Board of Zoning Adjustment

Staff Report

Case No:	18VARIANCE1013
Project Name:	Old Forester Distillery Signage
Location:	117 W Main Street
Owner(s):	Brown Forman Corporation
Applicant:	Kyle Hatfield – Nimlok Kentucky
Jurisdiction:	Louisville Metro
Council District:	4 – Barbara Sexton Smith
Case Manager:	Dante St. Germain, Planner I

4. Elevations

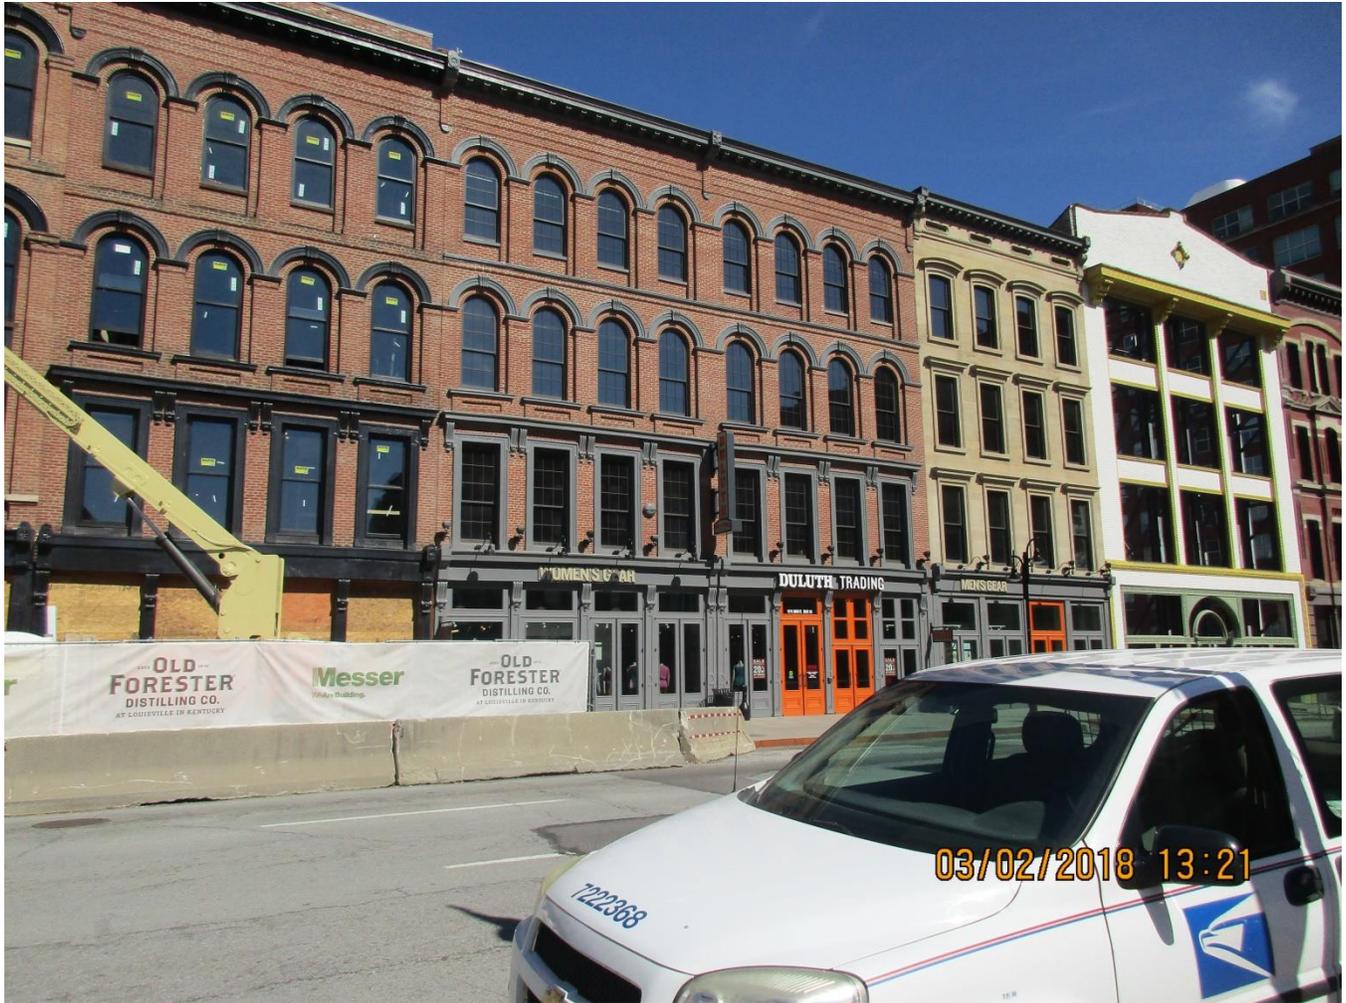
Distressed paint
1870 type to fit
above the top row
window decorative
arch molding and
the building cornice.
Some clipping is
acceptable.

Distressed paint
Brown-Forman logo
to fit below the top
row window apron and
middle row decorative
arch molding. Some
clipping is acceptable.

Blade sign
(high level)

Fixed window graphics

- 1. The painted signs should not appear “weathered” like on the drawings. The painted signs should be clean, crisp, and of their time in order to not create a false historicism.**
- 2. If the design or materials change, the applicant shall contact staff for review and approval.**
- 3. The applicant, owner, and/or their representative shall obtain the necessary approvals from other Louisville Metro Government agencies and departments.**
